*Proceedings of the Madras Government, Public Works Department,
8th May 1876.*

THE following notes of inspection of Irrigation Works in the Cuddapah District are submitted for the information of Government. The District Engineer accompanied me throughout the tour, and the Sub-

Notes on inspection
of Irrigation Works in the
Cuddapah District.

Sketches alluded to in para 16 of Memo
from Chief Engr: for Irrigation, printed with
G. O. No. 1300 dated 24th May 1876.

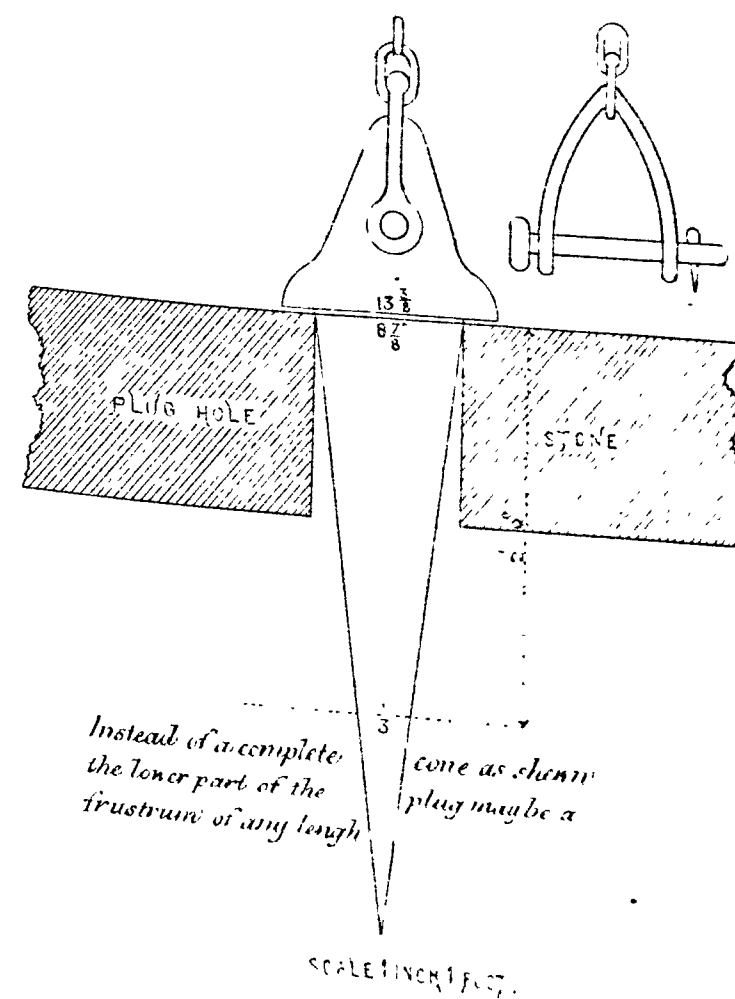
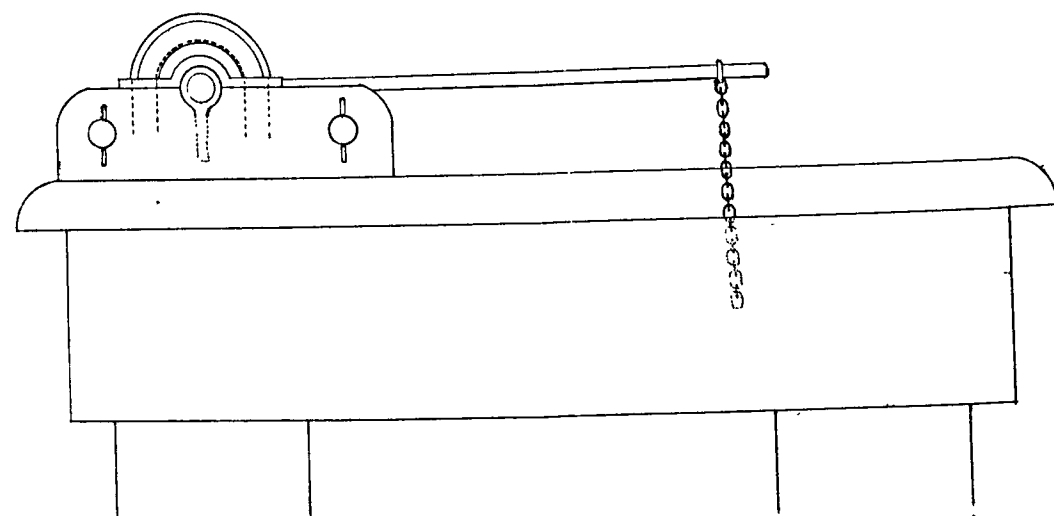
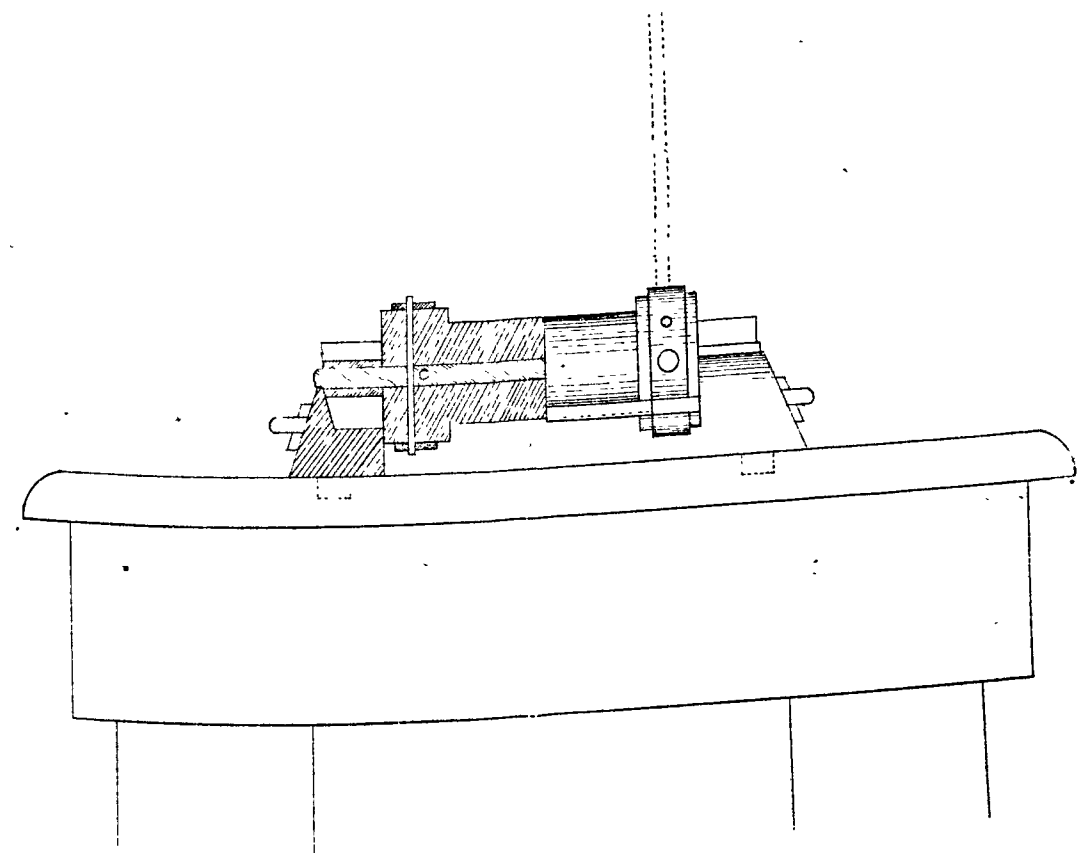
1st, the plugs should be well made with a long cone; a carefully cut shoulder which may be covered with a leather washer; and a suitable head; an appended sketch shows a plug suitable for a 9-inch plug hole. 2ndly, on the platform a small windlass should be fixed by means of which and a chain attached to the plug the latter can be raised or lowered as may be necessary. A sketch is appended, and all the parts have been designed so as to be capable of being made by village workmen when furnished with the iron and chain. No very good workmanship is needed. In some districts tank sluices having their heads out in deep water have been provided with new heads at the bund, and in cases in which the old heads have become ruinous or the tunnels unserviceable, it will generally be desirable to bring the heads back to the bund; but as, when the depth of water is great, new heads so placed cost a good deal, when only means of regulation are required to render existing sluices perfectly serviceable, no change of position need be made; but a platform above F.T.L. should be provided where there is none at present, and upon that the simple gear for working the plugs can be fixed. Stone columns are costly and difficult of erection, but coursed rubble masonry piers in cement can be substituted for columns, and if built 18 inches square at top with outside face batters of 1 in 12, they will answer the intended purpose. In this part of the country beam stones can be laid on the piers to form a platform.
